Access Compliance Report

Public Rights-of-Way

(Curb Ramps)

Intersection ID: 52442	Main Street: WOODWARD_AV	Cross Street: BENDING_BIRCH_PL	Location: SW
ADA ID: 2A53B93C1663	Ramp Type: Directional1	Initial Pass/Fail: Fail	Overall Compliance: No
		Severity Score: 12.5

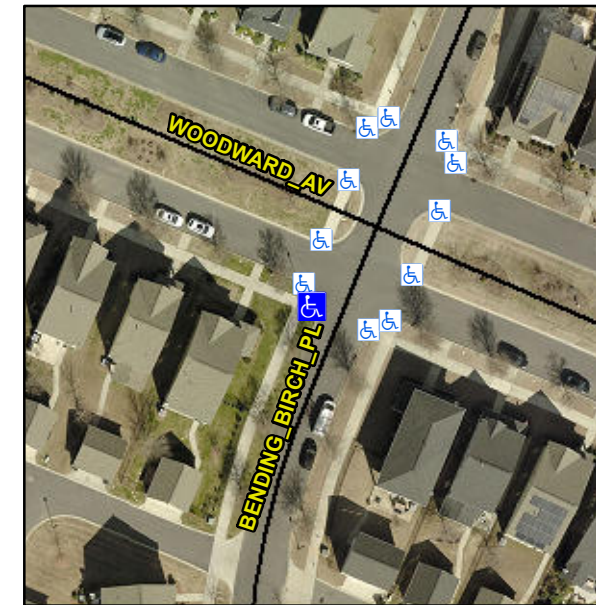
R304.2.2

Compliance	Description	Data	Compliance	Description	Data
N/A	Ramp Length (in)	68.0	N/A	Grade Break?	N/A
Yes	Ramp Width (in)	60.5	N/A	Grade Break Slope (%)	0.0
No	Ramp Slope (%)	9.8	N/A	Grade Break XSlope (%)	0.0
Yes	Ramp XSlope (%)	0.2			
N/A	Flare Type LT	N/A	N/A	Flare Type RT	N/A
N/A	Flare Slope LT (%)	N/A	N/A	Flare Slope RT (%)	0.0
N/A	Flare Traversable LT?	N/A	N/A	Flare Traversable RT?	N/A
N/A	Landing Length (in)	0.0	N/A	DWS Provided?	N/A
N/A	Landing Width (in)	0.0	N/A	DWS Contrast?	N/A
N/A	Landing Slope (%)	0.0	N/A	DWS Length (in)	N/A
N/A	Landing X Slope (%)	0.0	N/A	DWS Full Width?	N/A
N/A	Landing Curb? (Y/N)	N/A	N/A	DWS Offset LT (in)	N/A
N/A	Shared Landing?	N/A	N/A	DWS Offset RT (in)	N/A
N/A	Gutter Ponding?	0.0	N/A	Gutter Slope (%)	N/A
N/A	Gutter Lip Ht (in)	1.5	N/A	Gutter X Slope (%)	N/A
N/A	Painted X Walk1?	No		Road Slope (%)	2.9
	X Walk 1 Direction	To E		Road X Slope (%)	1.6
	X Walk 1 Width (in)	N/A		Clear Space?	N/A

Remove & Replace Entire Ramp.
